NUCLEAR ENERGY INSTITUTE

NEI 17-02

Tornado Missile Risk Evaluator (TMRE) – Resolution of NRC Staff Comments

Figure 3-1. Plan View of Safety Related Structures

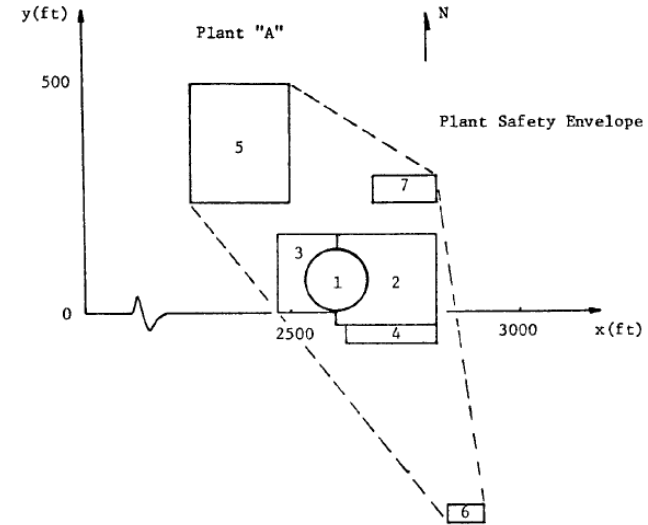
#10.b - Response

- Building 1 (Containment) is 230 feet tall, but lower portion of building is completely shielded by Buildings 2 (Aux Bldg) and 3 (Fuel Handling Bldg)
 - Aux Bldg is 80 feet tall and Fuel Handling Bldg is 60 feet tall, so all exposed surfaces of Building 1 are >30' above grade
- EPRI NP-768 Plant A TORMIS simulations assume uniform distribution of initial missile elevations from 5' to 50' above grade, so some missiles are within 30' of exposed surface on west (FHB) side of Building 1

#10.b - Response

- Use of containment data in deriving <30' MIP leads to lower (less conservative) <30' MIPs
- >30' MIPs are derived in a conservative manner, since they include entire surface of all buildings, including surfaces less than 30' above grade
- TMRE methodology provides conservative tornado failure probabilities, when compared to TORMIS-based failure probabilities in RG 1.200 HW PRAs (Appendix A)
- Sensitivity case factors (2.5x and 2.75x) are significantly greater than increase in MIP, if it were derived without Building 1

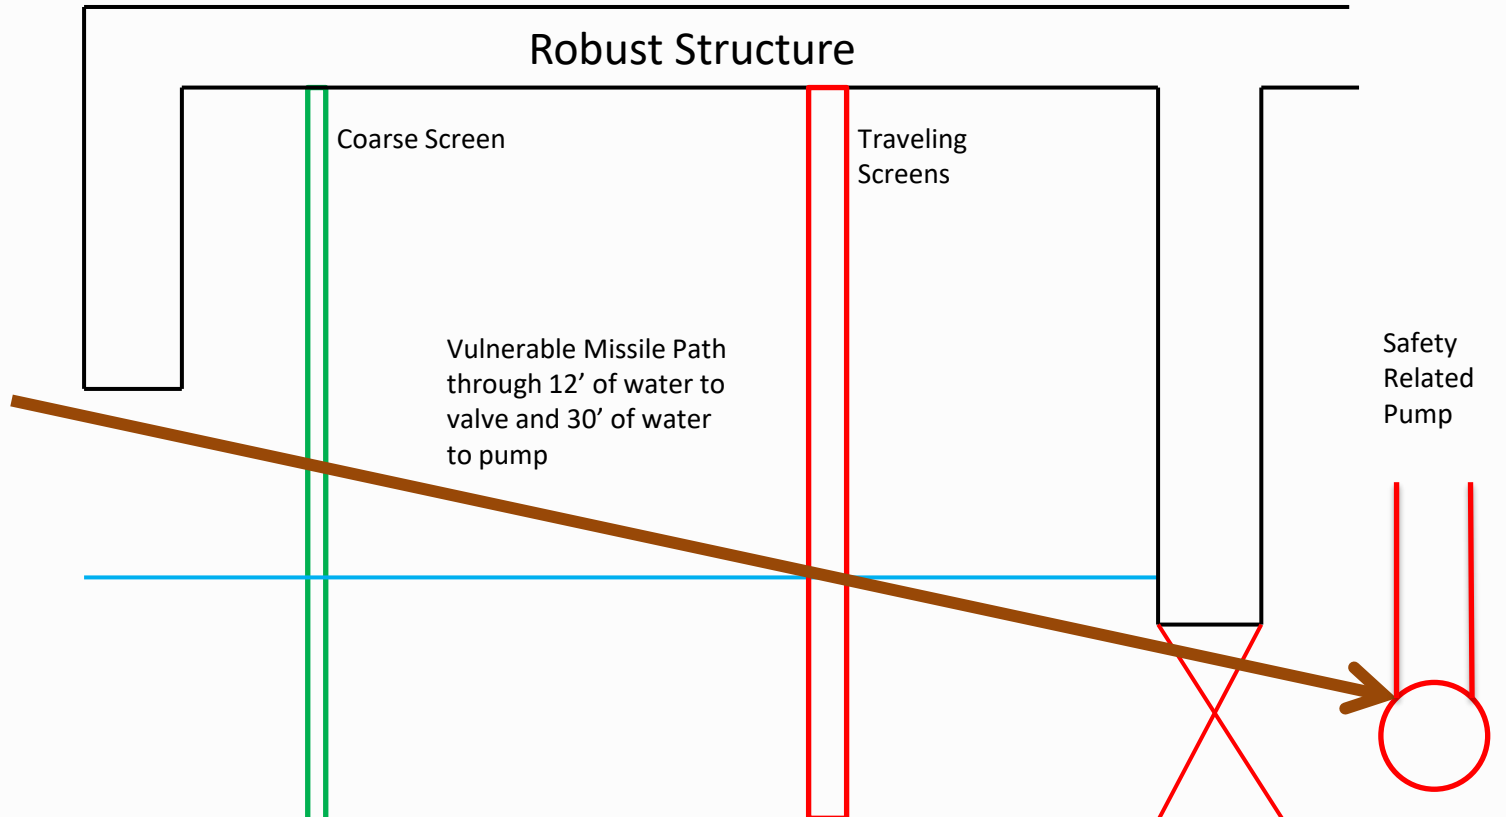
#4.b - Response

- Duke Energy determined that there is minimal value in documenting and having NRC review the technical justification for the De Minimis screening approach.
- Duke Energy withdrew the aspect of its LAR related to the De Minimis screening approach in letter dated January 11.
- As the De Minimis screening approach was described in NEI 17-02, Rev. 1, which was incorporated by reference into the LAR, the explicit aspects of the methodology requested to be withdrawn were attached as marked-up pages.
